SUBJECT: SALEM NUCLEAR GENERATING STATION, UNIT NO. 1 (TAC NO. M95383)

Amendment No. 201
License No. DPR-70

ATTACHMENT TO LICENSE AMENDMENT NO. 201

FIGURE 2.1-1
 REACTOR CORE SAFETY LIMIT - FOUR LOOPS IN OPERATION

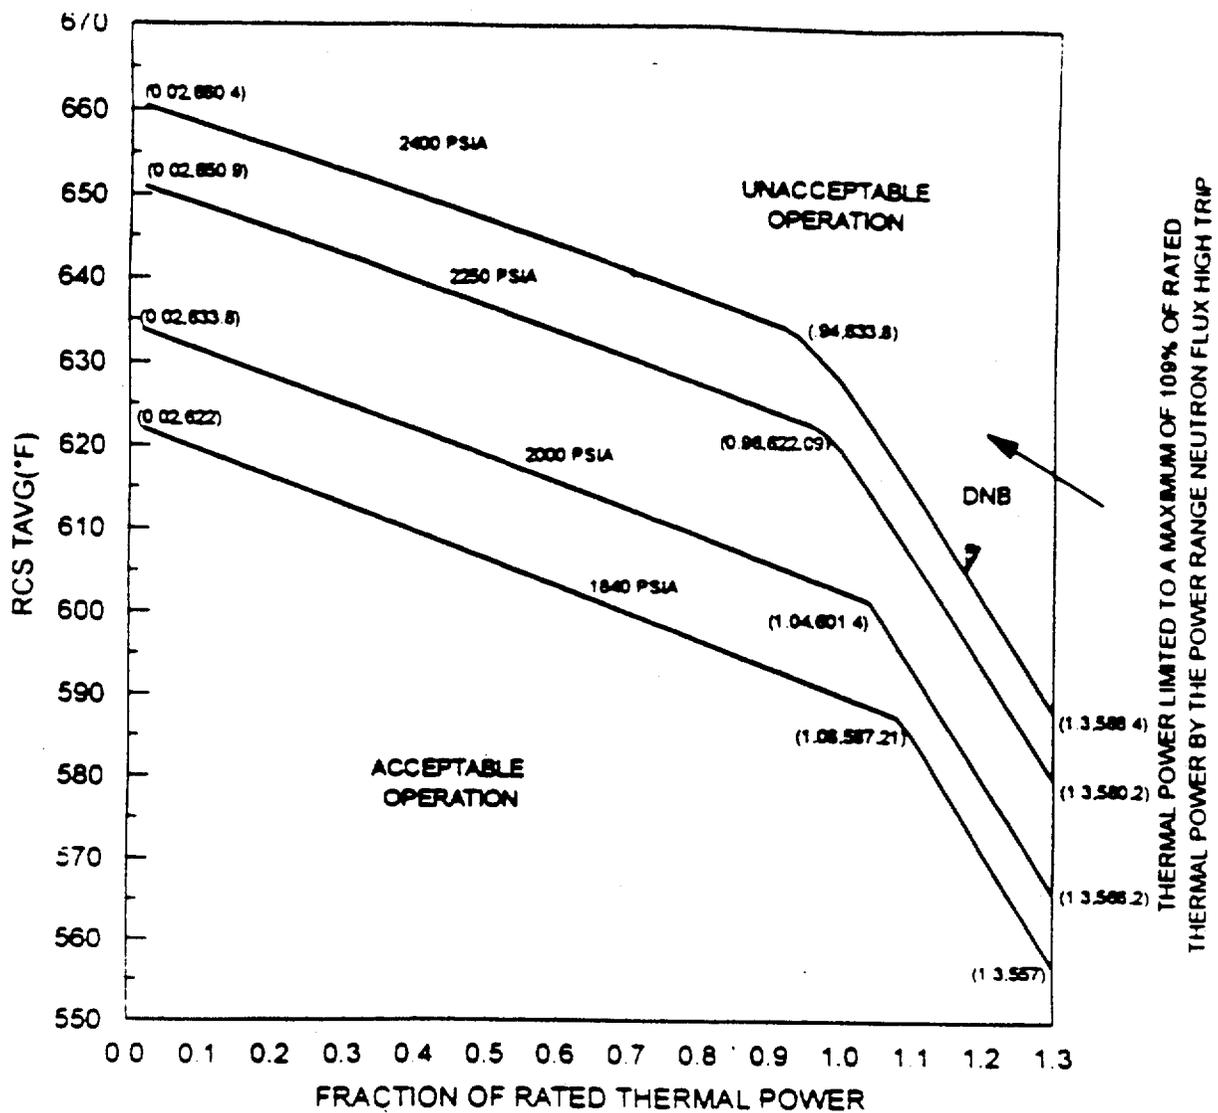
2.1.1 The combination of THERMAL POWER, pressurizer pressure, and the highest operating loop coolant temperature (T_{avg}) shall not exceed the limits shown in Figure 2.1-1 for 4 loop operation.

The curves of Figure 2.1-1 shows the loci of points of THERMAL POWER, Reactor Coolant System pressure and average temperature for which the minimum DNBR is no less than the design DNBR value, or the average enthalpy at the vessel exit is equal to the enthalpy of saturated liquid.
